6. 80 Grafton Street (PID #340265)

TITLE: <p style="text-align: center;"> DESIGN REVIEW FILE: PLAN-2019-17-MAY-6a 80 GRAFTON STREET (PID #340265) OWNER: 1867 DEVELOPMENTS INC. APPLICANT: BILL CHANDLER </p>		 CHARLOTTETOWN
MEETING DATE: May 17, 2019		Page 1 of 5
DEPARTMENT: Planning & Heritage	ATTACHMENTS: <ul style="list-style-type: none"> A. GIS Maps B. Council Resolution C. First Design Review Submission D. Preliminary Design Reviewer Comments E. Second Design Review Submission F. Design Reviewer Comments (April 29, 2019) G. Third Design Review Submission H. Design Reviewer Comments (May 16, 2019) 	
SITE INFORMATION: Context: Vacant property in the 500 Lot Area Ward No: 1 – Queen Square Existing Land Use: Vacant Parking Lot Official Plan: Downtown Mixed-Use Neighbourhood Zoning: Downtown Mixed-Use Neighbourhood (DMUN) Zone		
PREVIOUS APPLICATIONS: Council passed a resolution on November 13, 2018 for a site specific exemption including three variances to allow the development of this application.

Re: Design Review for 80 Grafton St – 5 Storey Mixed Use .

A8 13	Project	GRAFTON ST PROPOSAL
	Scale	1/8" = 1'-0"
	Date	FEB 13, 2009
	Sheet Title	ELEVATION

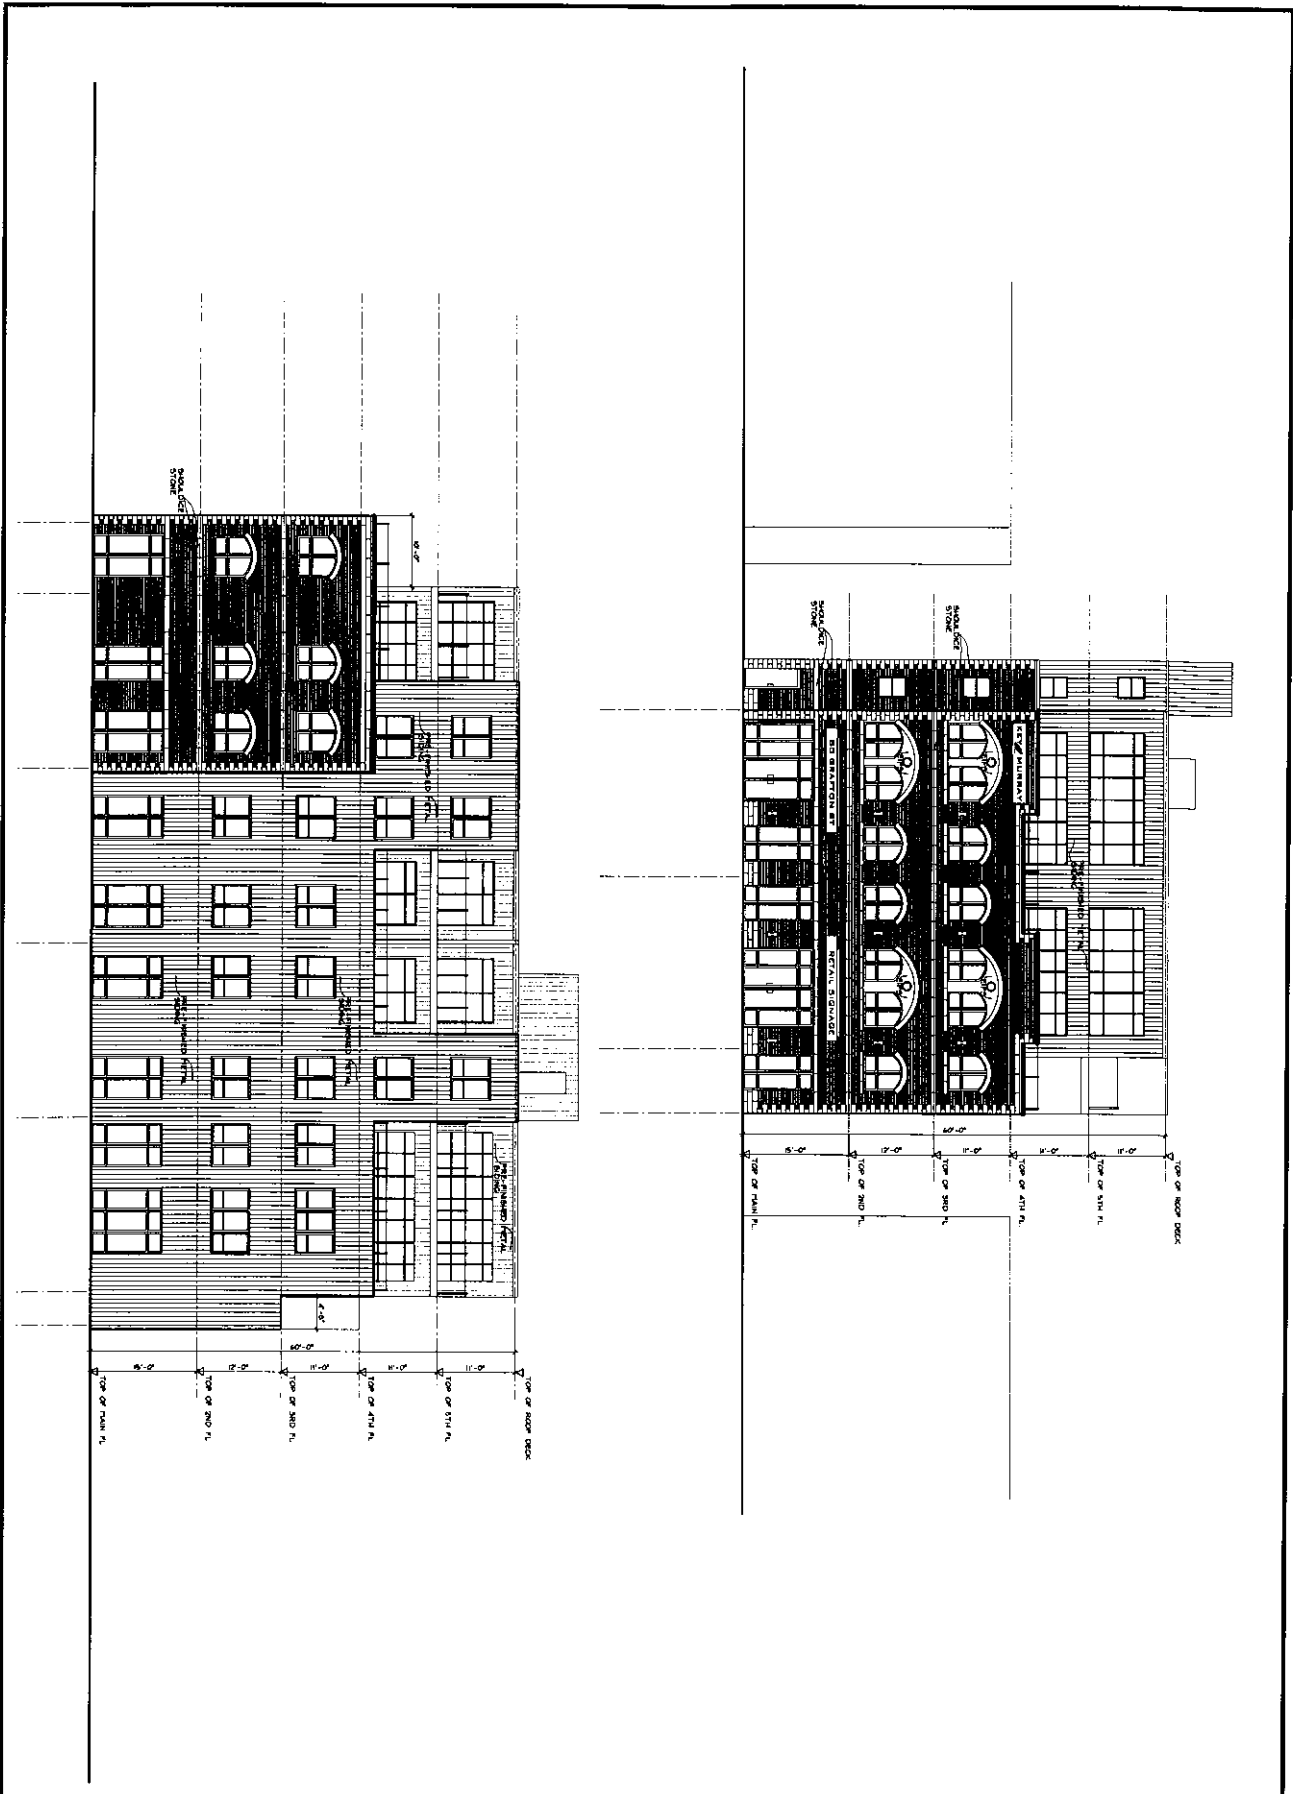
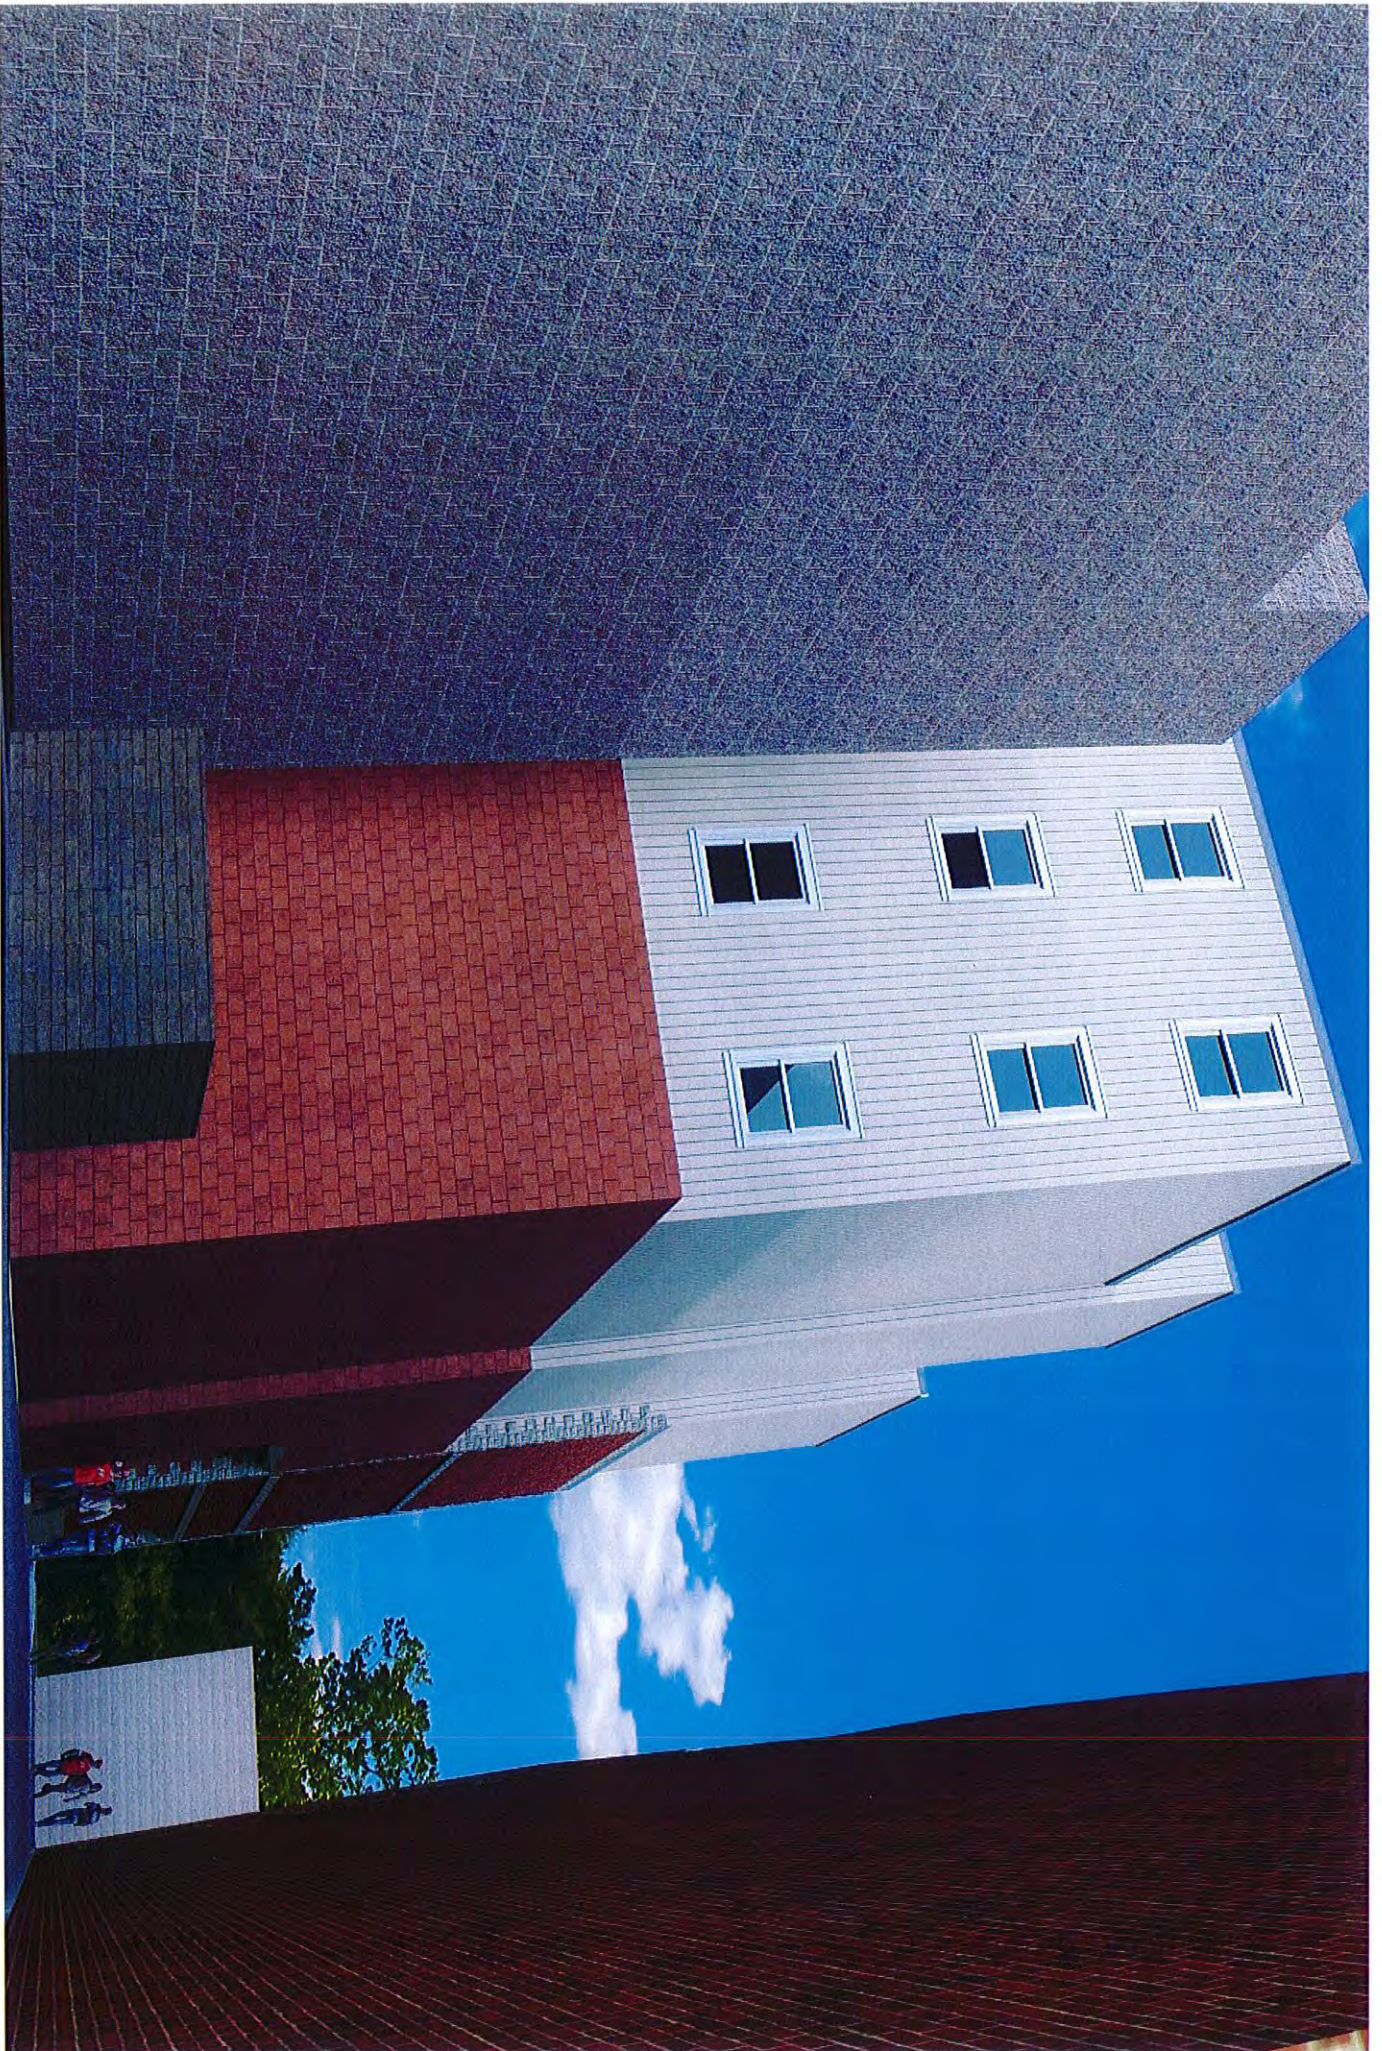
Greg Munn, RM, commented that the guidelines when doing an infill building is not to try to recreate or give a false sense of history and this design makes it look like it is trying to be an older building. It is trying to give a false sense of history and a significant change or difference in material between lower and upper portion. It then looks like an older building that has two floors added instead of a single construction. The intent is not to put a false sense of history in newer buildings. Mr. Munn understands that the applicants are trying to work on the materials and the massing which are good things, but it may be going too far in terms of making it too historic. Mr. Chandler responded that it is not intended to fake heritage. But there is pressure from the owners to make it look contemporary. Brian Gillis, RM, asked if you are directed by the investor to build this style and Mr. Chandler confirmed to some extent.

The architect has selected a route of blending the new development into the existing street context by emulating its surroundings. It is the opinion of the design reviewer that if this is the approach, then the building should be clear in its detailing supporting the tradition load bearing masonry construction. It should be relevant to the 500 Lot area and in accordance with established “orders: and details of that architectural style. **“Section 10 of guiding principals and Section 5.3.1. of the 500 Lot Standards and Guidelines discourages historic mimicry with incorrect or inappropriate detailing.”**

Section 7.3 Front façade height and width	<p>7.3.1 The primary plane of the front façade shall not appear taller than traditional Buildings on the Street, unless the adjacent Building marks an identifiable transition in Building style and/or land use.</p> <p>7.3.2 Building elements that are taller than the primary plane of the front façade shall be designed to contrast that of the lower levels in materials and/or design.</p> <p>7.3.4 For Larger wider buildings, vertical subdivisions or bays in the façade at a width consistent with the street.</p>	<p>The building primary façade is taller than both adjacent neighbours.</p> <p>The architect has made a strong change in appearance to the upper (2) Floors of the building. Steel Cladding, is proposed. However there is very little detailing presented. The design needs more refinement and detailing. There is no expression of floor plates, or cornices.</p> <p>The current design does not break the façade down into smaller subdivisions.</p>

Section 7.4 Building Materials	<p>The Front and Flankage facades shall carry a consistent type and quality of materials. Where a Side Yard Setback is greater than 3 m (9.8 ft), the Side facade shall also carry a consistent material. This clause also applies to the rear façade on a Corner Lot when the Rear Yard is greater than 3 m (9.8 ft).</p> <p>7.4.4 Metal Siding Using Exposed Fasteners is not allowed.</p>	<p>The architect has revised the drawings to further extend the masonry construction down the public walk-way. It doesn't fully match the word of the by-laws, however with limited view down this walk-way, I believe the revision meets the intent.</p> <p>Confirm that final material detailing has not exposed fasteners.</p>

Section 7.5 Windows	All Sections	The proportion and detailing of the windows are not well aligned with the style of the building. Arch top windows – the mainstyle on the primary façade are not continued on the step-backed portion of the street façade (A8 Elevation)
Section 7.6 Roof	All Sections	The current design meets the intent of this section.
Section 7.7	All Sections	At this level of development - The current design meets the intent of this section. – Review final location of plumbing stacks, HRV and exhaust fan locations during design development.
Section 7.9	7.9.1 A Landscaped Area shall be provided between the sidewalk and the front façade of the Building, where appropriate for a continuous streetscape.	Not Applicable
Section 7.12 Storefronts	7.12.1 – 7.12.3	The revised drawing has increased the amount of glass on the storefront. However there a lot of inconsistencies in column widths. Windows are returned at entries, but masonry is left between the windows, emphasizing the thinness of the brick veneer. Section 7.12.3 requests an identifiable transition between ground floor and upper floors. The pilot house has a clear example of material differentiation and window size changes from reference.

Attachment D: Preliminary Design Reviewer Comments

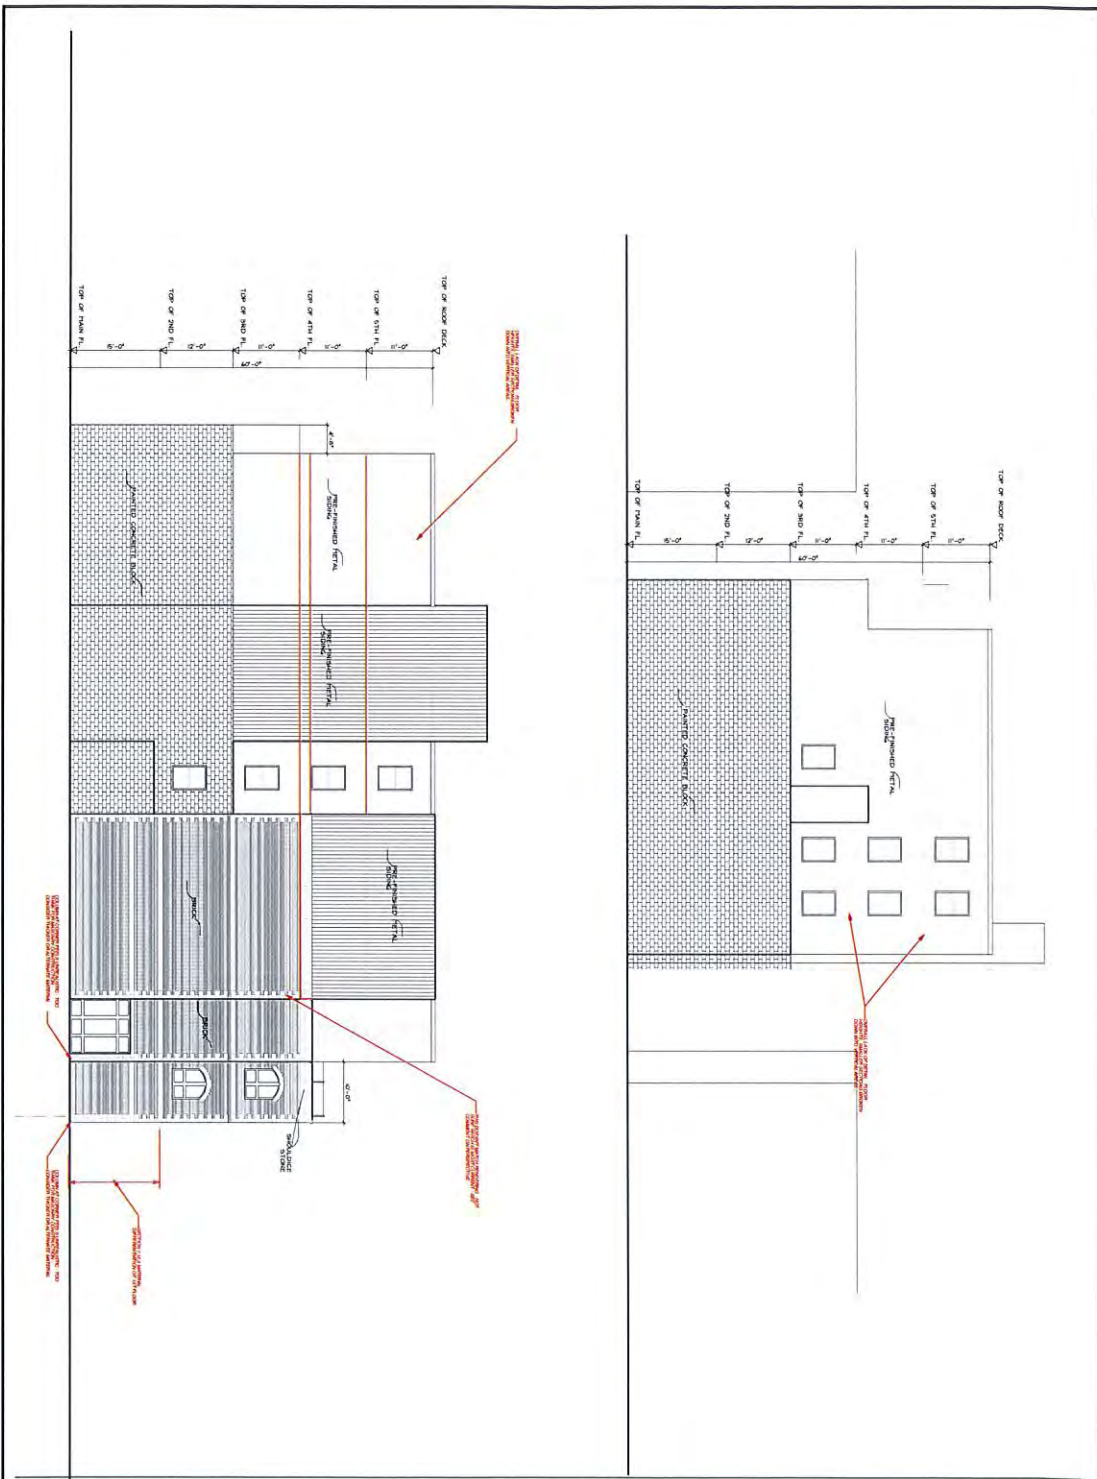
The strong contrasting colour scheme of the shouldice stone and windows de-emphasizes the solidity associated with masonry construction. The window proportions do not reflect load bearing masonry walls. They are too wide and not tall enough. The stucco infill between the windows, is inappropriate. Typically in paired arch-topped windows, there is the masonry opening, and then contained within, is a pair of wood mulled windows. The material and colour located in the masonry opening is consistent.

The fact that the building has been positioned to create a public landscaped area leading toward a new entry to the parking garage, yet the primary entry is located on the opposite side of the building. Second means of egress and main entry all open to the service alley instead of the public landscaped area..

When located between two building of different heights, the taller cornice height shall prevail.	The proposed design does not meet the intent of this section.
	Maintain Heights and Proportions of the 1 st Storey	The proposed design does not meet the intent of this section.
	Reinforce the prevailing rhythm of heritage buildings – generally narrow vertical Proportion	The proposed design does not meet the intent of this Section. Both the building front width and window proportions.
		Glass Guardrails at upper decks need to be pull back from the front façade.

ELEVATION
op 1

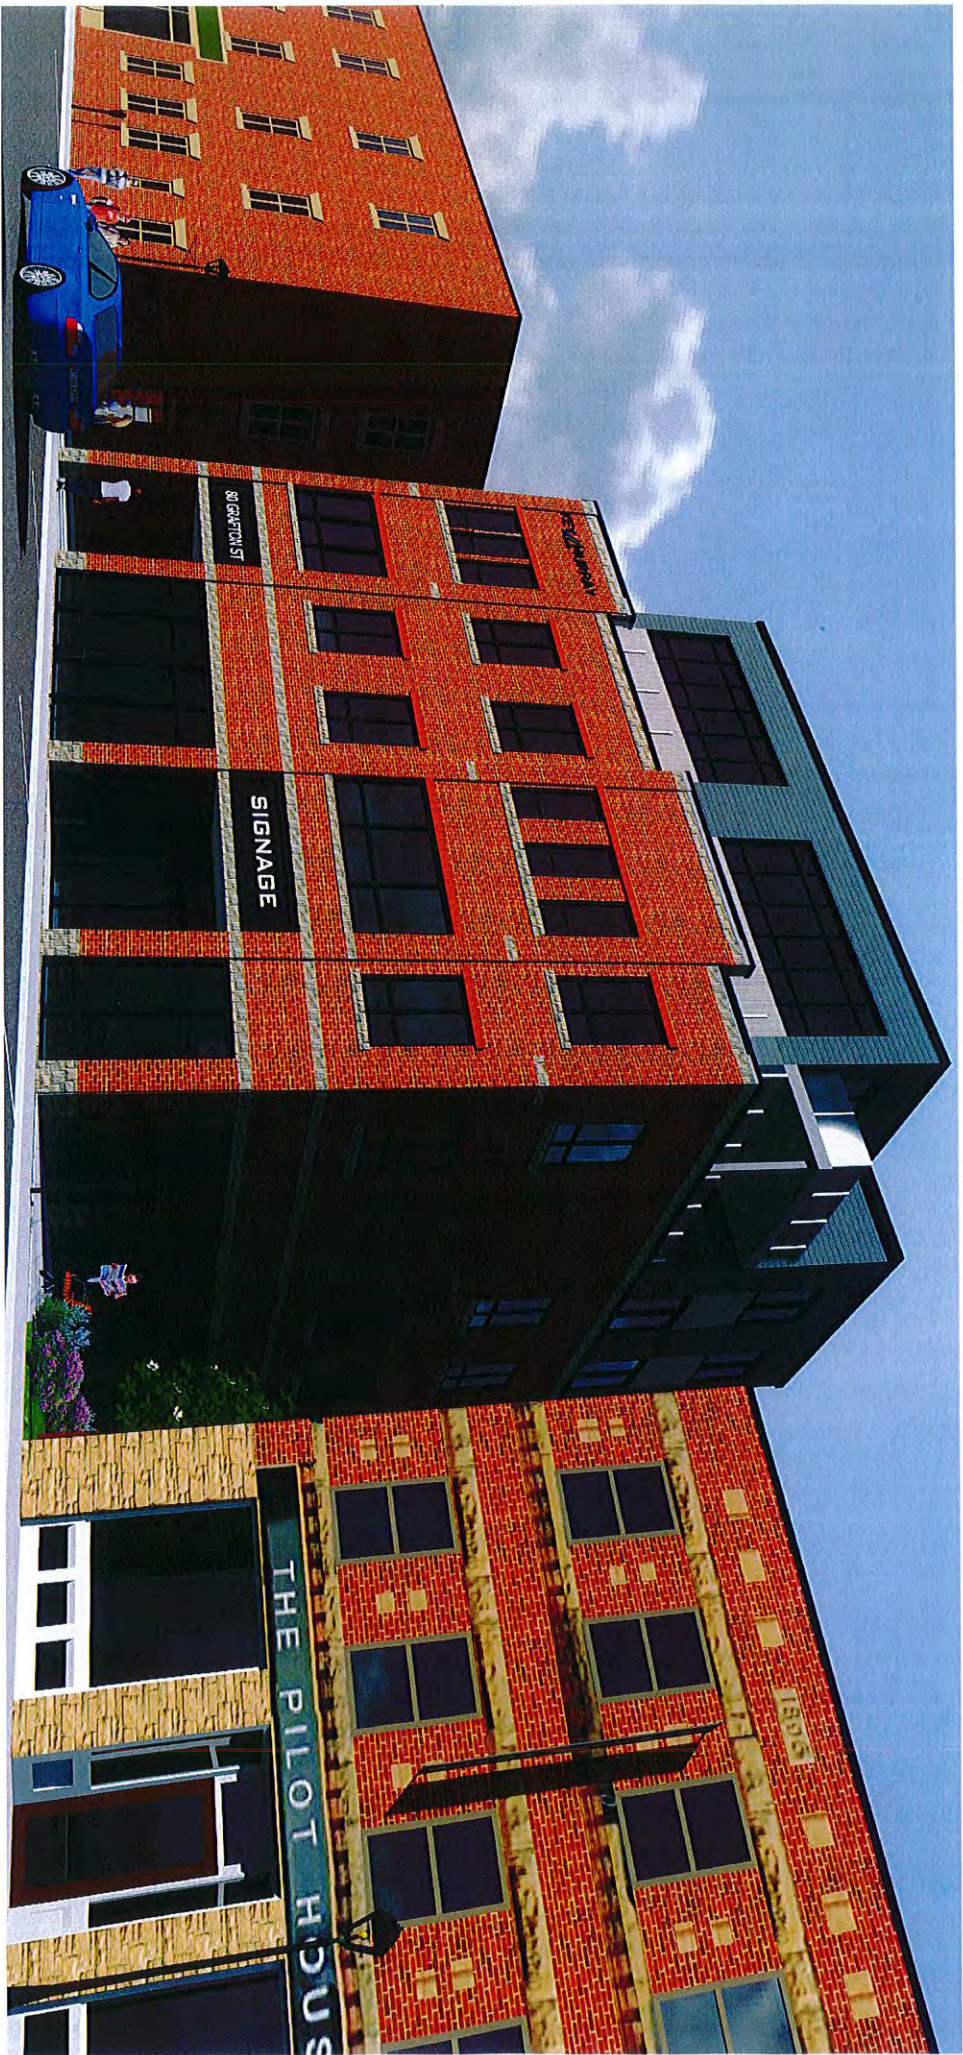
The architect has revised the design to break-down the overall width of the front façade using masonry pilasters. A vertical proportion, similar to the traditional street pattern is more clearly established. The arch top windows have been replaced with clear punched openings on floors 2 and 3, with masonry elements between the openings. This is in contrast to the more commercial 1st floor. This approach is encouraged in the 500 Lot guidelines and illustrated design manual. The use of Shouldice stone has been limited, and in the opinion of the design reviewer has regained the emphasis of a monolithic masonry building. The architect has worked to achieve unity between the more traditional masonry base and the contemporary top through consistent materials coloring.

When located between two building of different heights, the taller cornice height shall prevail.	The submitting architect has clarified heights of existing buildings and the proposed building is very closely related to the existing MRSB.
	Maintain Heights and Proportions of the 1 st Storey	Proportions have been revised. – This meets the intent of the by-laws.
	Reinforce the prevailing rhythm of heritage buildings – generally narrow vertical Proportion	Integrated Pilasters and more consistency in material has improved the façade. Meets the intent.

Glass Guardrails at upper decks need to be pull back from the front façade. – Architect and Developer to avoid, residential style aluminum and glass guardrail system. – Frameless system would be more appropriate.
--	--	--

Further, *'the architect has revised the design to break-down the overall width of the front façade using masonry pilasters. A vertical proportion, similar to the traditional street pattern is more clearly established. The arch top windows have been replaced with clear punched openings on floors 2 and 3, with masonry elements between the openings. This is in contrast to the more commercial 1st floor. This approach is encouraged in the 500 Lot guidelines and illustrated design manual. The use of Shouldice stone has been limited, and in the opinion of the design reviewer has regained the emphasis of a monolithic masonry building. The architect has worked to achieve unity between the more traditional masonry base and the contemporary top through consistent materials coloring.'*

'Architect and Developer to avoid, residential style aluminum and glass guardrail system. – Frameless system would be more appropriate.'
